# One Rincon Hill Residential Development

## **FINAL ENVIRONMENTAL IMPACT REPORT**

**San Francisco Planning Department  
Case No. 2003.0029E**

● Indicates material that is new or has been revised since publication of the Draft EIR.

## Comments and Responses Figure 1 - Bike Path Easement

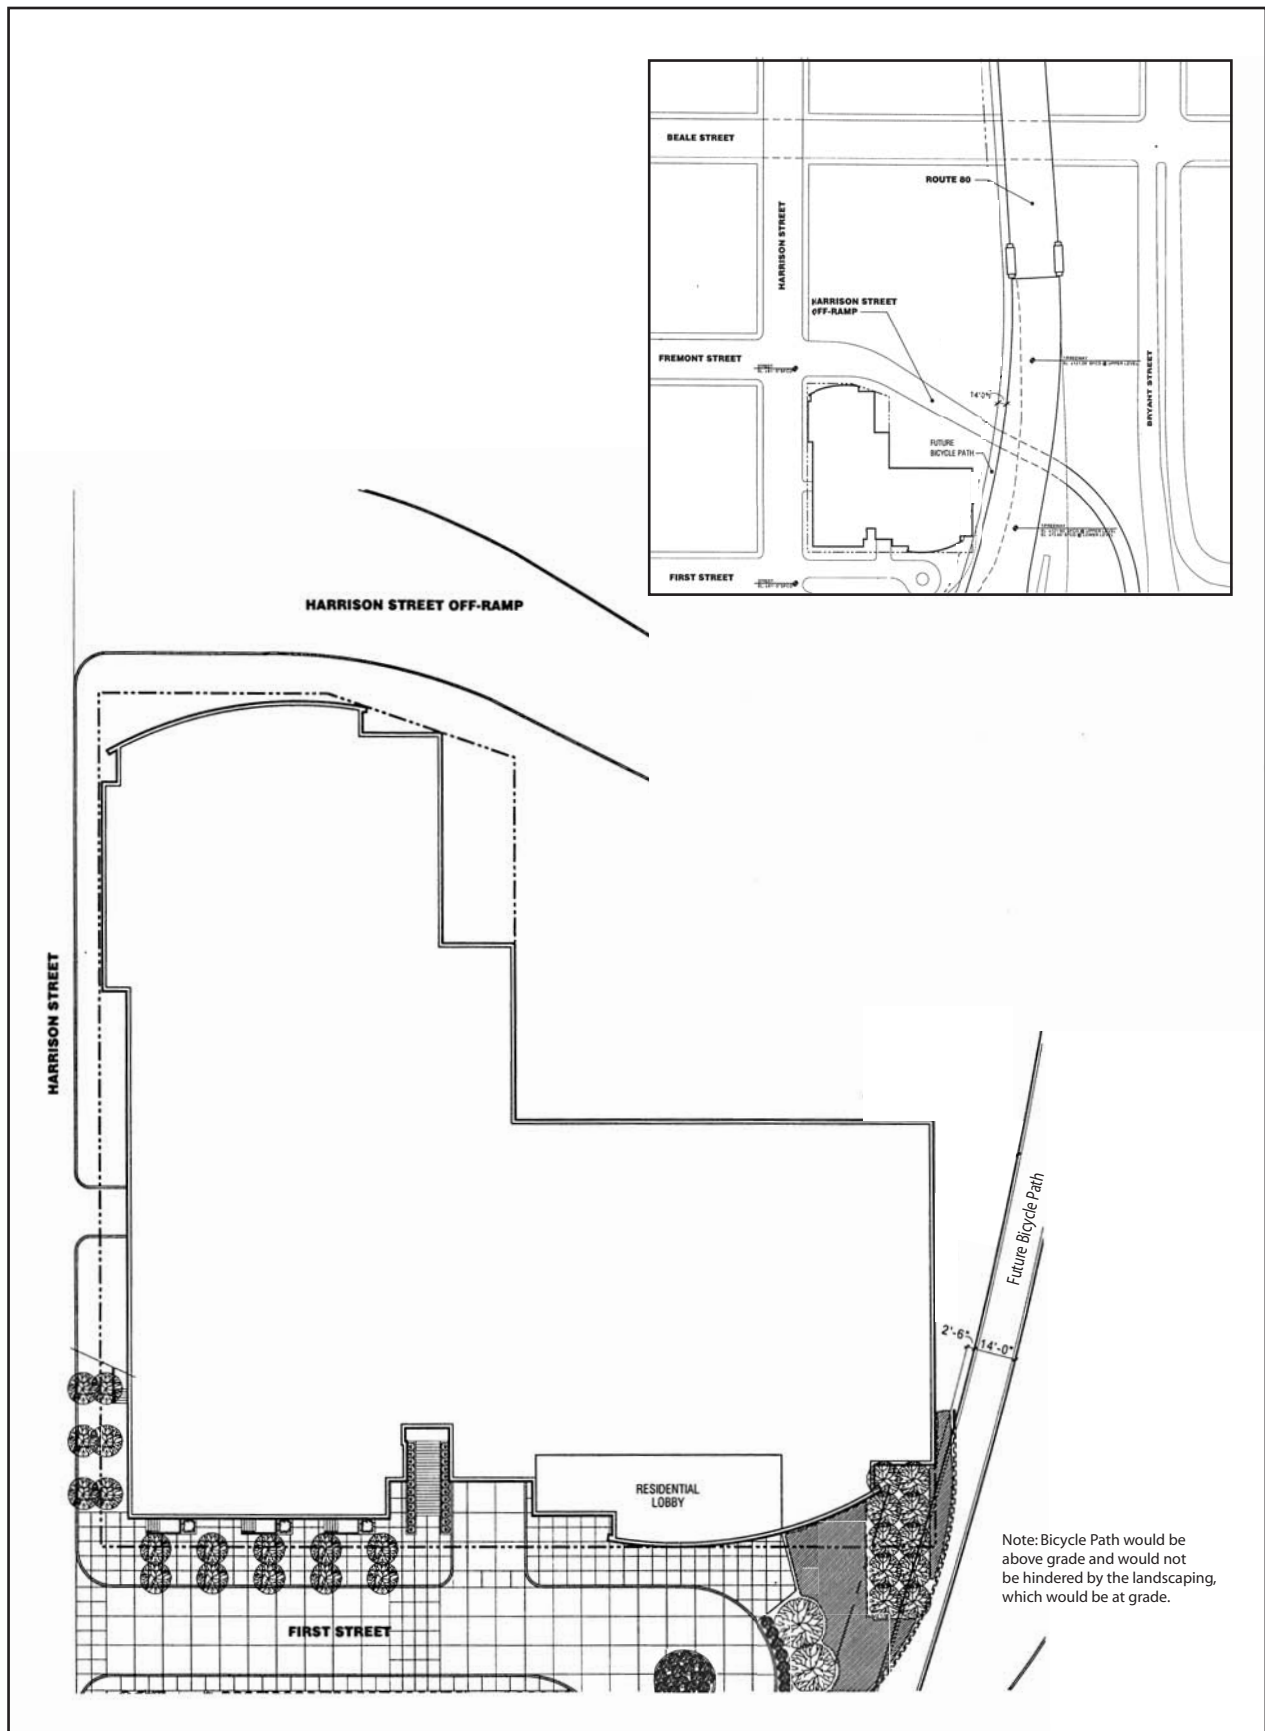
Pages 115 & 116, Paragraph 3: traffic lane closures fall under the purview of the CCSF Department of Parking and Traffic. (*Timothy C. Sable, Caltrans*)

The applicant for the One Rincon Hill project (also known as the 425 First Street project) has reached an understanding with Caltrans regarding a redesign of the bikeway to avoid the proposed buildings (see C&R Figure 1) and that the applicant would provide an easement to Caltrans to accommodate the redesigned Bay Bridge bicycle path alignment.<sup>13</sup> The proposed project buildings would not be located in the redesigned bike path alignment. Therefore, the feasibility of the bicycle path would not be affected by the proposed project. As noted in the Supplement to the *Rincon Hill Plan*, and by the commenter, funds have not been allocated to date for the pathway.
